Access Compliance Report

Public Rights-of-Way

(Curb Ramps)

Intersection ID: 53979	Main Street: MESHACK_AV	Cross Street: CASRACK_ST	Location:	E
ADA ID: 922572AEC30E	Ramp Type: Perp	Initial Pass/Fail: Fail	Overall Compliance: No	Severity Score: 10
Codes/Mitigation Info/Possible Solution		Field Measurements/Component Compliance

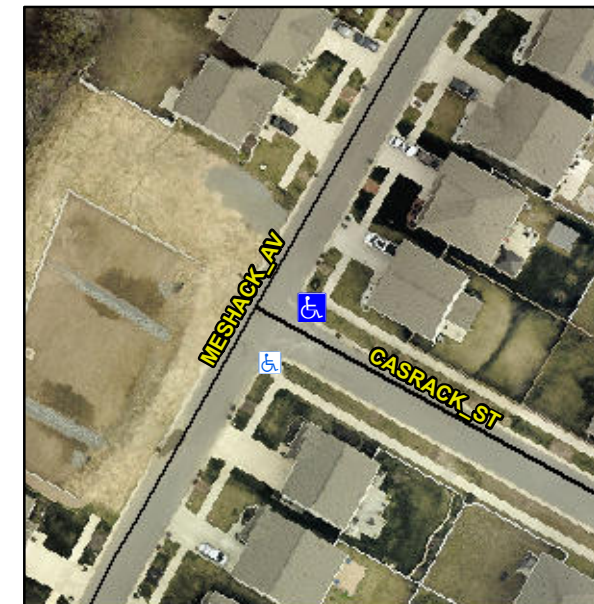
Not Found, R304.5.1, R304.5.3

Compliance	Description	Data	Compliance	Description	Data
N/A	Ramp Length (in)	104.0	Yes	Ramp Slope (%)	5.4
No	Ramp Width (in)	46.0	No	Ramp XSlope (%)	3.0
N/A	Flare Type LT	N/A	N/A	Flare Type RT	N/A
N/A	Flare Slope LT (%)	N/A	N/A	Flare Slope RT (%)	N/A
N/A	Flare Traversable LT?	N/A	N/A	Flare Traversable RT?	N/A
N/A	Landing Length (in)	N/A	N/A	DWS Provided?	N/A
N/A	Landing Width (in)	N/A	N/A	DWS Contrast?	N/A
N/A	Landing Slope (%)	N/A	N/A	DWS Length (in)	N/A
N/A	Landing X Slope (%)	N/A	N/A	DWS Full Width?	N/A
N/A	Landing Curb? (Y/N)	N/A	N/A	DWS Offset (in)	N/A
N/A	Shared Landing?	N/A			
N/A	Gutter Ponding?	N/A	N/A	Gutter Slope (%)	N/A
N/A	Gutter Lip Ht (in)	2.0	N/A	Gutter X Slope (%)	N/A
N/A	Painted X Walk1?	No	N/A	Painted X Walk2?	N/A
	X Walk 1 Direction	To S		X Walk 2 Direction	N/A
N/A	X Walk 1 Width (in)	N/A	N/A	X Walk 2 Width (in)	N/A
	X Walk 1 Slope (%)	0.4		X Walk 2 Slope (%)	N/A
	X Walk 1 X Slope (%)	2.6		X Walk 2 X Slope (%)	N/A

Remove & Replace Entire Ramp.
